April 4, 2005

Re: Review of Proposed Lighthouse Landing Development
Village of Sleepy Hollow, New York

Adler Consulting has conducted a careful and balanced review of the Lighthouse Landing Draft Environmental Impact Statement (DEIS). Based on this review, it is concluded that the DEIS does not present a complete and accurate picture of the impact the development will have on the Village of Tarrytown. Specifically, the Project's traffic impacts have been underestimated, no attempt was made to estimate the Project's impact on parking in the Tarrytown central business district (or, for that matter, in the Sleepy Hollow business district), no attempt was made to estimate the Project's impact on emergency response times in the village and no mitigation was proposed for the impacts associated with truck traffic generated by the Project, either before or after its completion. Even with these deficiencies, it is clear that the Project will have both traffic and parking impacts in Tarrytown which must be mitigated, either by practical physical improvements or through a major reduction in the Project size.

Title:
**Impacted Intersections
 in Tarrytown**

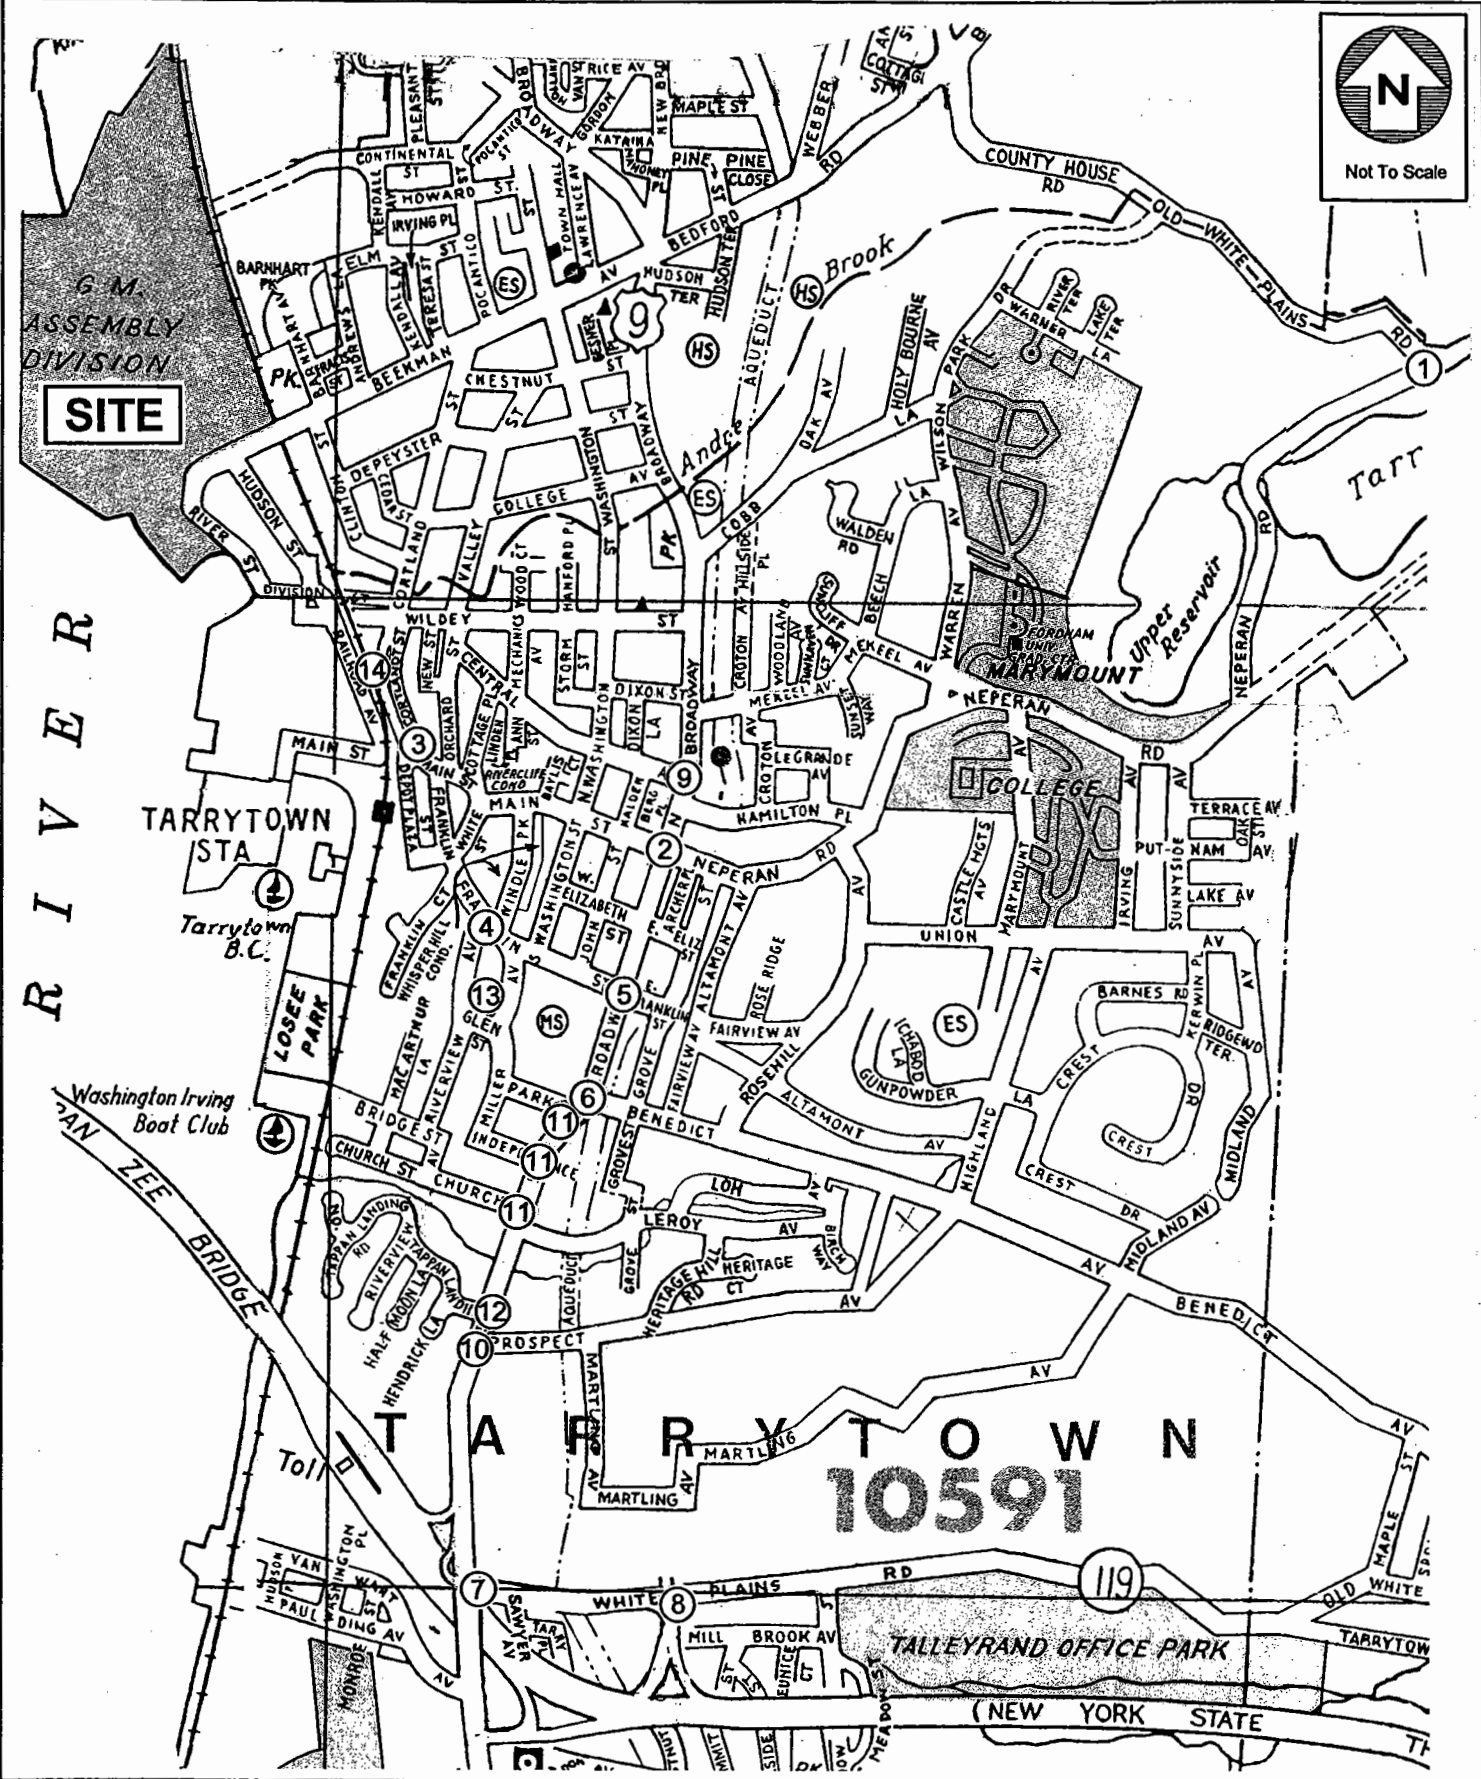
Based on a review of the DEIS, it is clear that the proposed Lighthouse Landing development will have a significant impact on traffic at the following locations in the Village of Tarrytown, the locations of which are shown on the attached map:

1. **County House Road at Neperan Road (around the Tarrytown Lakes) -** Overall failing ("f") conditions will be worsened by approximately 13 percent in the morning peak hour and by 10 percent in the evening peak hour, although greater increases in delays will be encountered on some of the

2. **US Route 9 at Main Street** - Borderline tolerable ("E") conditions at this intersection are projected to be worsened to clearly failing ("F") conditions during the morning peak hour at this location, with delays projected to increase by 45 percent. During the evening peak and Saturday hours, clearly failing conditions are projected to be worsened by approximately 25 percent. The analyses indicate that it will take longer than 3 minutes to pass through this intersection and the Project's impact can be mitigated by the elimination of 15 on-street parking spaces to create north and southbound left-turn lanes on Broadway (p III.I-41). Even with these improvements, overall failing conditions are still projected to prevail after the Lighthouse Landing development is completed.

3. **Main Street at Depot Plaza** - The DEIS indicates that the addition of Project traffic to this intersection will reduce operating conditions from a Level-of-Service "B" to a Level-of-Service "F" during the Peak AM and Saturday Hours and the prevailing failing conditions in the PM will be worsened by a factor of almost 2. These increases in delays will be experienced almost exclusively by motorists leaving the Lighthouse Landing development. The DEIS indicates that signal timing modifications will be required "to accommodate the future traffic volumes" and mitigate for the Project's impacts (p III.I-42).

4. **Riverview Avenue at Franklin Street** - The DEIS indicates that the addition of Project traffic to this intersection will reduce operating conditions from a Level-of-Service "c" to a Level-of-Service "f" during the Peak AM and PM Hours and that one possible improvement to mitigate for the impact of project traffic "would be the restriction of left-turn movements from the Riverview Avenue approach" (p III.I-42). Furthermore, the Applicant should indicate the impact of the prohibition of left-turns at this location on traffic operating conditions at the adjacent intersection of Miller Avenue with Franklin Street.

5. **Franklin Street at Broadway** - Although the DEIS acknowledges on page III.I-42 that "a police officer is stationed at this intersection to direct traffic during critical time periods" the Existing and No-Build analyses do not reflect this condition. They should be revised accordingly so that the Project's true

6. **Benedict Avenue at Broadway** - The Applicant should indicate whether the Build analyses of this intersection have included the left-turns that are proposed to be prohibited at the intersection of East Franklin Street with Broadway. Regardless, the DEIS indicates that operating conditions will be reduced from "D" to failing "F" Levels-of-Service during the Peak AM and Saturday Hours as a result of the Lighthouse Landing development. During the Peak PM Hour, operating conditions are projected to be reduced from "E" to failing "F" conditions. To "accommodate future traffic volumes at this intersection (page III.I-43) the DEIS recommends that the northbound right-turn lane be converted to a through/right-turn lane. This recommendation also requires the elimination of the on-street parking as discussed for the previous intersection.

7. **NY Route 119 at Broadway** - The DEIS indicates that the addition of Project traffic to this intersection will reduce operating conditions from a Level-of-Service "C" to a Level-of-Service "E" during the Peak PM Hour. To mitigate for this impact, the DEIS recommends that the Route 119 approach be restriped to permit right turns from the middle lane as well as from the right-hand lane (p III.I-43).

8. **NY Route 119 at the I-287 Westbound Ramps** - The DEIS indicates that the addition of Project traffic to this intersection will increase the average delay on "E" level-of-Service operating conditions by 32 percent during the Peak PM Hour. To mitigate for this impact, the DEIS recommends that slight signal timing modifications be implemented.

9. **Central Avenue at Broadway** - Although the DEIS does not assign any traffic to the intersection of Central Avenue with Broadway (as previously discussed) it does note that prevailing operating conditions will be at failing ("f") levels

10. **Broadway at Prospect Avenue** - Although the DEIS does not analyze the intersection of Broadway with Prospect Avenue, the FEIS should include an analysis of this intersection. This intersection is listed in the joint January 2005 correspondence from the Villages' traffic consultants as "arguably the most congested intersection in the Village of Tarrytown." The DEIS analyses revealed that the Project will have a significant adverse traffic impact at the closest signalized intersecting streets upstream and downstream from this intersection, for which mitigation was identified. It is, therefore, clear that the Project will also have a significant adverse traffic impact at this intersection. The FEIS should include an analysis of this intersection and identify necessary mitigation measures as appropriate.

11. **Broadway at Church Street, Independence Street and Park Avenue** - Although the DEIS does not analyze the intersection of Broadway with Prospect Avenue, the FEIS should include an analysis of this location. It is expected that, cumulatively, 100 peak-hour trips will be added to these unsignalized approaches to Broadway, which already experience considerable delays during the Peak PM Highway Hour, and that these additional trips will have a significant impact at these locations.

12. **Broadway at Tappan Landing Road** - Although the DEIS does not analyze the intersection of Broadway with Prospect Avenue, the FEIS should include an analysis of this intersection. It is expected that, the development will increase traffic volumes by approximately 15 percent at this intersection, which is currently experiencing poor operating conditions and where residents have no alternative means of accessing the surrounding roadway network.

13. **Miller Park Neighborhood** - The DEIS fails to recognize or mitigate for the Project's traffic impacts on the already overburdened Miller Park neighborhood where, based on the data available in the Lighthouse and Ferry Landing's developments, it is calculated that more than 100 trips will be added to these local residential streets unless specific and effective traffic calming measures are identified and implemented.

14. **The H-Bridge** - The Ferry Landings DEIS identified that that Project would impact the H-Bridge but that the impact could be mitigated by the installation of new, interconnected traffic signals at the H-Bridge Ramp intersections. Since the Lighthouse Landing development is projected to generate almost three times as much traffic across the H-Bridge as the Ferry Landings development, it stands to reason that the Lighthouse Landing development will also impact the H-Bridge and will require the same mitigation.
